Re: Sewer Plan Approval
Summit Drive Sewer Main Extension
Plat 16-4 / Lots 449 & 459

Re: Preliminary Sewer Plan Review
Summit Estates -Minor Subdivision
Summit Drive, Cranston, RI

Veolia Water North America (VW) has completed its review of the preliminary construction plans entitled: "Summit Estates, prepared for Summit Estates, LLC, prepared by Advanced Civil Design, Inc., dated May 2023, last revised 6/9/23, submitted on June 19, 2022.

STAINLESS STEEL LATERAL ASSEMBLY
NO FITTINGS

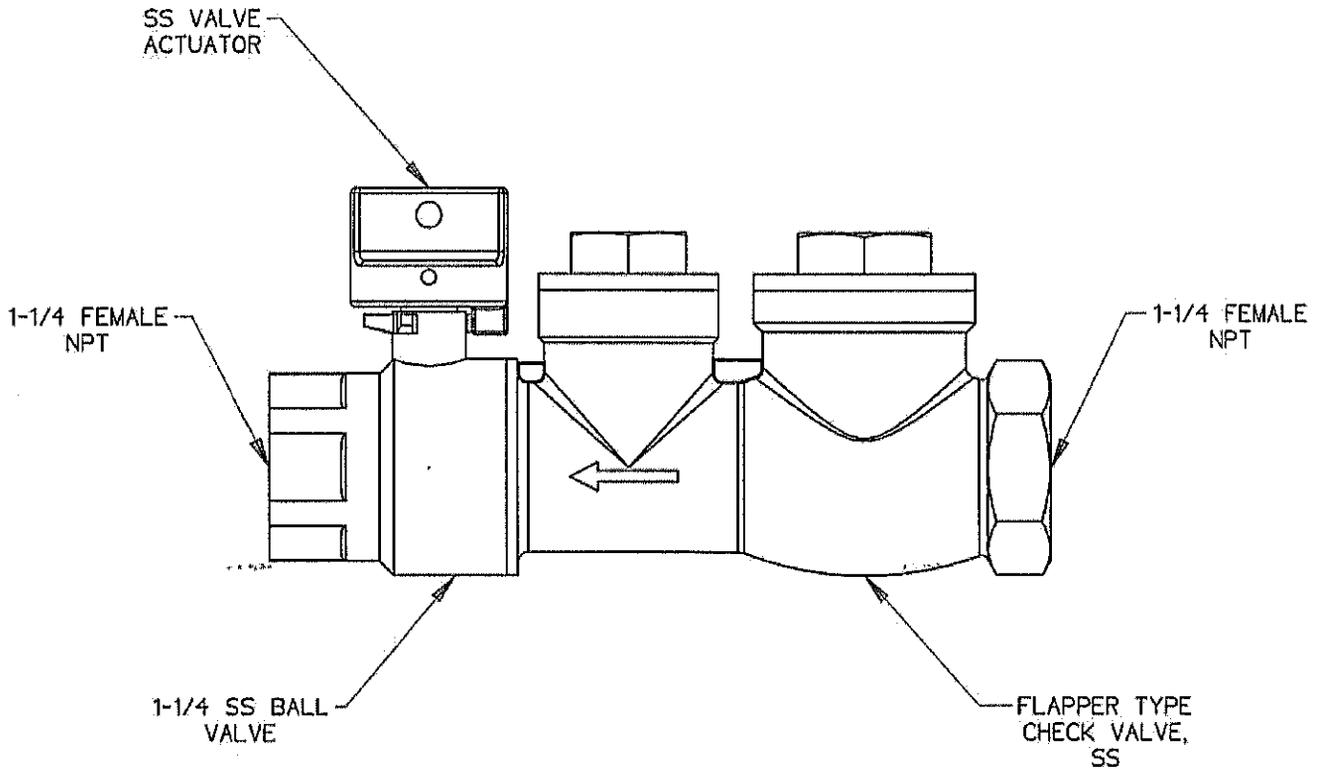
1. Sewer concrete encasement shall be 6" all around.
2. Terminal flushing manhole shall meet City's standard. See attached detail.
3. No trench detail for the low pressure force main provided. LPFM installation shall meet City requirements. See attached detail.
4. An e-one stainless steel lateral assembly w/ check valve shall be installed at the property line. See detail.
5. Note, an as-built plan will be required. And, as such said plan shall be Cranston Mean High Water (CMHW) datum. Attached please find an as-built plan checklist.
